Work Order ID 130374

Item ID: D407-667-105

Item Name: Fwd Crosstube - High 407

DRAWING NO. D407-667-145	TITLE CROSSTUBE ASS'Y (407 HIGH FWD)	REV. C	DART AEROSPACE LTD ENGINEERING ORDER		D.E.O. NO. D407-667-145-C-1	SHEET NO. SHEET 1 OF 1	SCALE NTS
DRAWN 90	CHECKED ASS	MFG. APPR. IB	APPROVED WD		DE APPR. H		
DATE 11.07.15	DATE 11.07.22	DATE 11.07.22	DATE 11/07/22		DATE 11.07.21

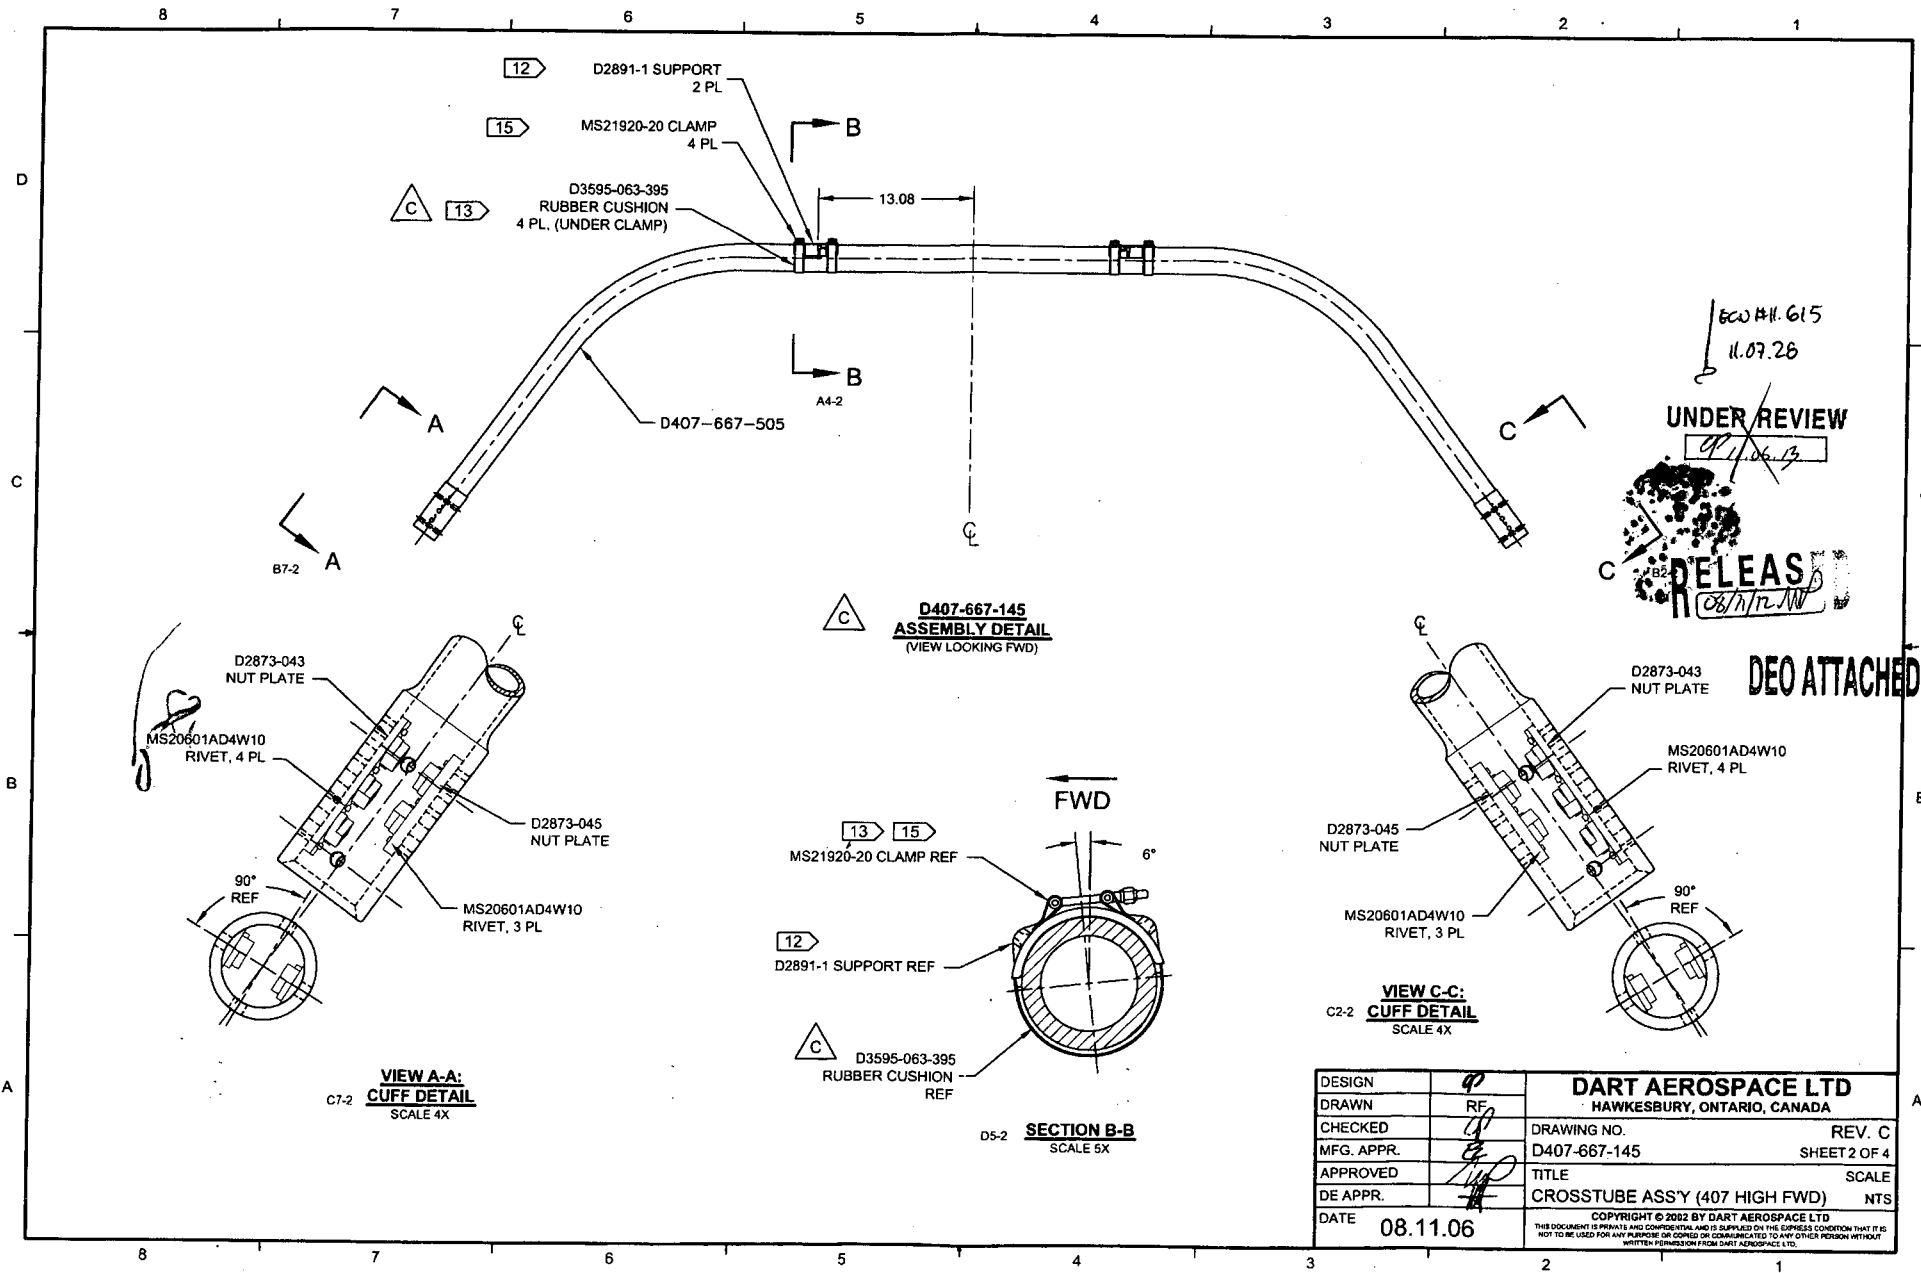
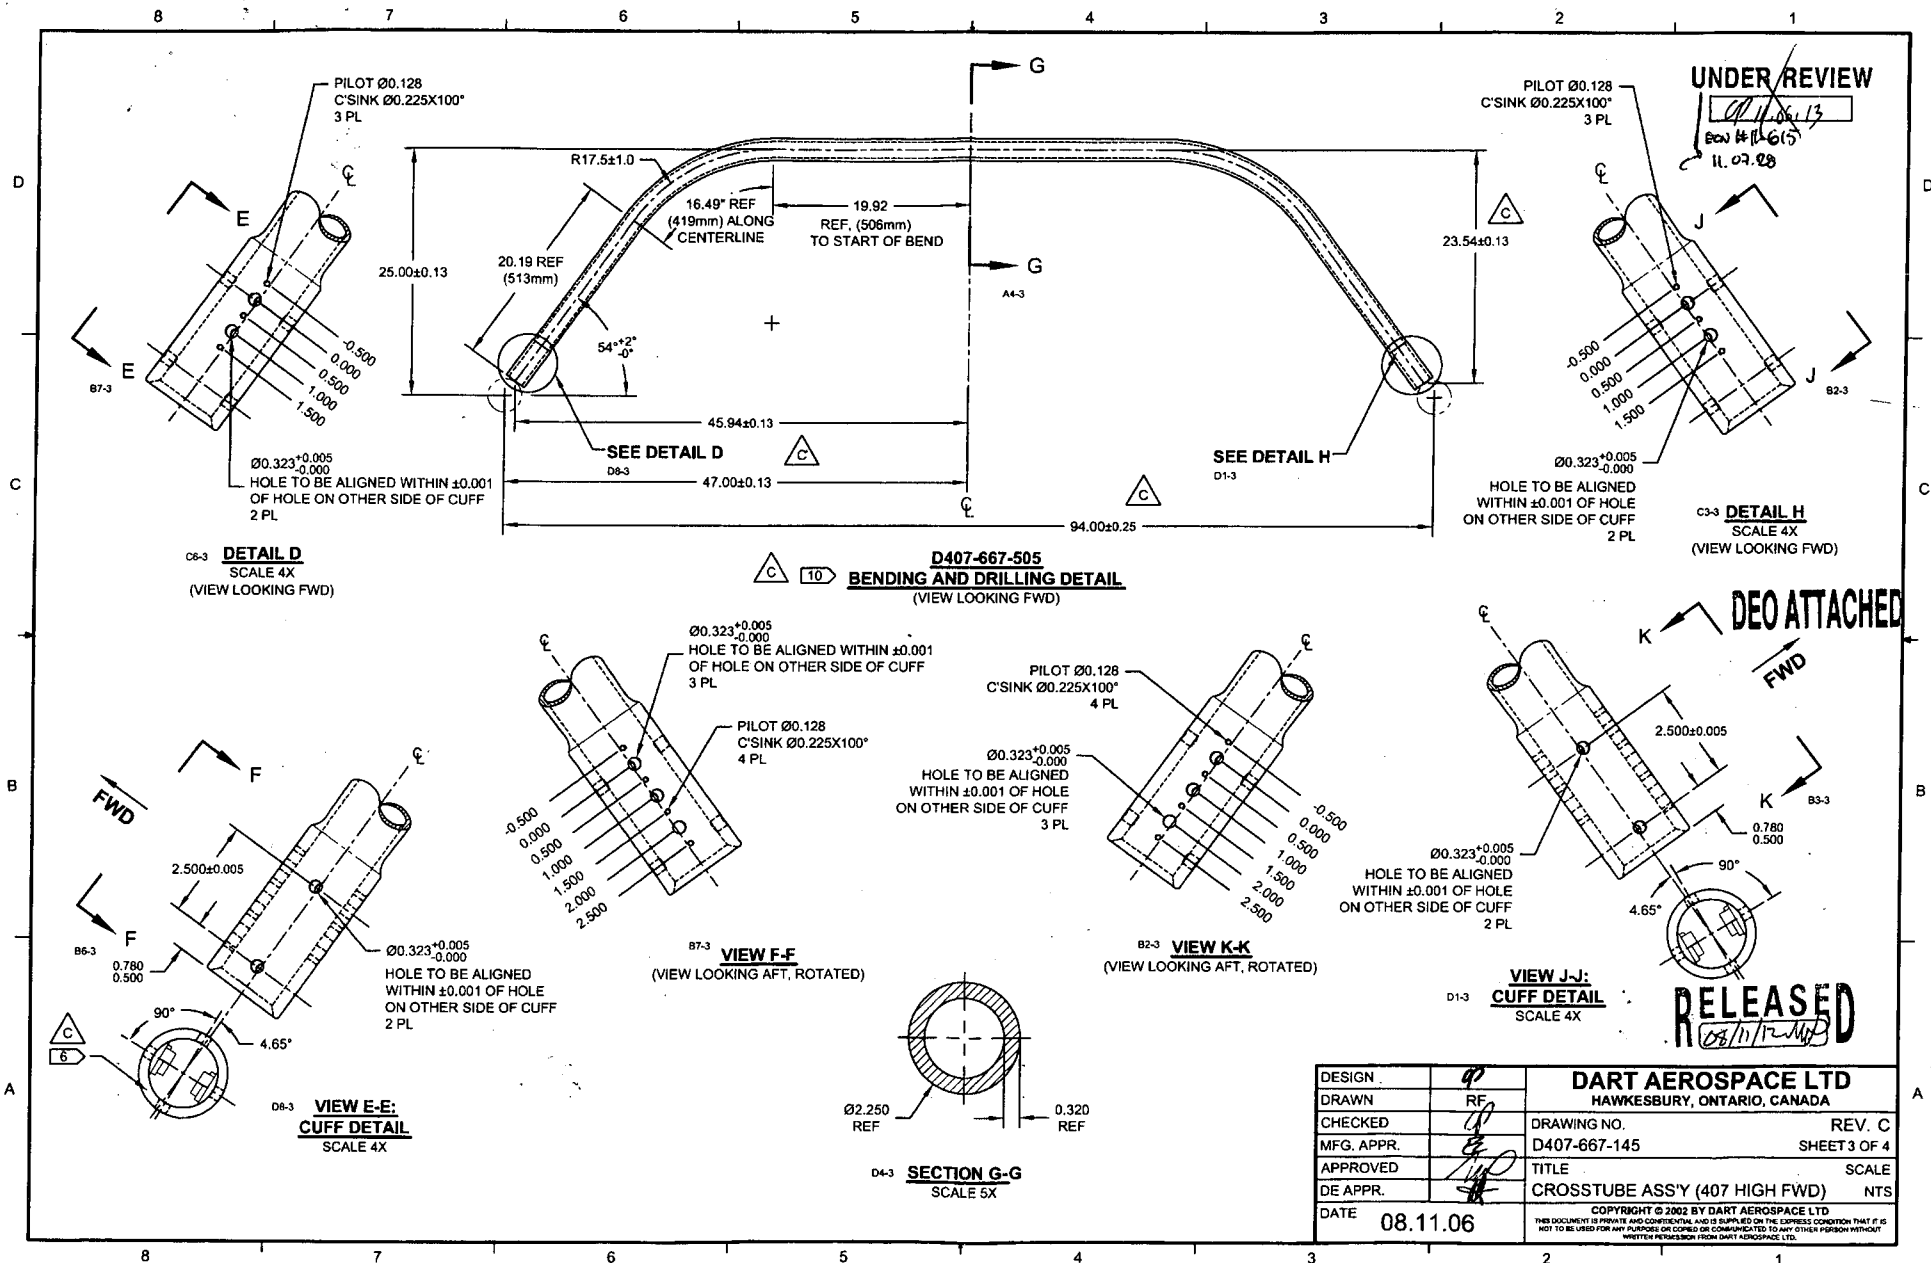
REPLACE MAGNOBOND WITH PROSEAL.

NOTE 12 & 15, SHEET 1 IS AMENDED AS FOLLOWS:

- 12) TO INSTALL D2891-1 SUPPORT: ABRAD MATING SURFACE OF SUPPORT AND CROSSTUBE WITH 180-GRIT SANDPAPER AND REMOVE RESIDUE WITH MEK (OR EQUIVALENT). APPLY A 0.04" TO 0.07" THICK LAYER OF PROSEAL 890 CLASS B-2 (OR AMS-S-8802 CLASS B-2) SEALANT TO MATING SURFACE OF SUPPORT.
- 15) TORQUE CLAMPS 80 TO 100 IN-LB. ENSURE AT LEAST 1.5 THREADS SHOWING IN SAFETY AND THAT NUT HAS NOT BOTTOMED-OUT AFTER TORQUING. **PRIOR TO PACKAGING, RE-CHECK TORQUE ON CLAMPS AFTER PROSEAL 890 SEALANT HAS CURED FOR 72 HOURS.**

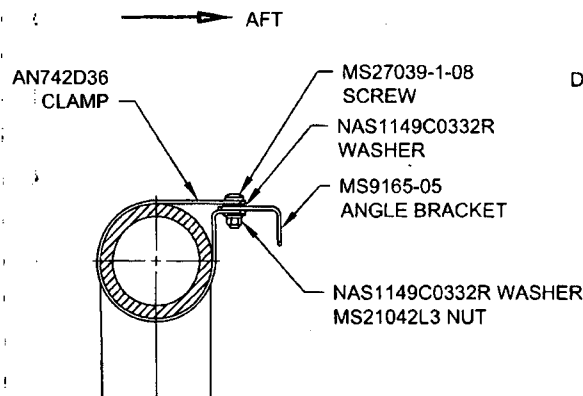
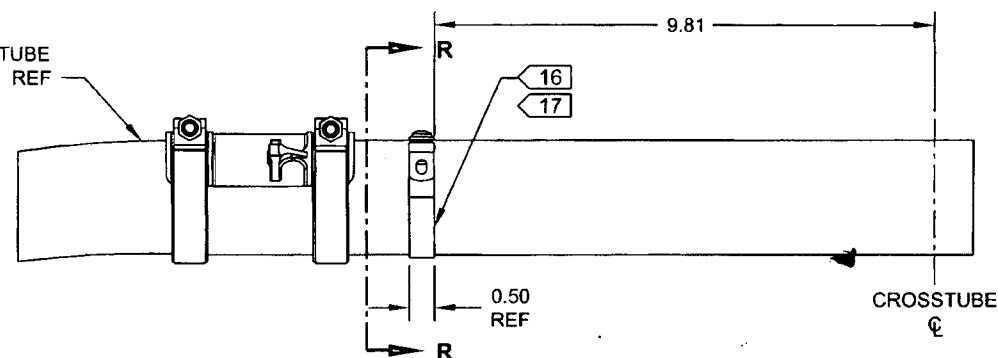
ADD ELECTRICAL GROUNDING STRAP

ADD

ADD

ITEM	QTY -145	PART NUMBER	DESCRIPTION
1	X	D407-667-145	CROSSTUBE ASSEMBLY (407 HIGH FWD)
10	2	AN742D36	CLAMP
11	2	MS9165-05	ANGLE BRACKET
12	2	MS21042L3	NUT (OR MS21042-3)
13	2	MS27039-1-08	SCREW
14	4	NAS1149C0332R	WASHER (OR AN960C10L)
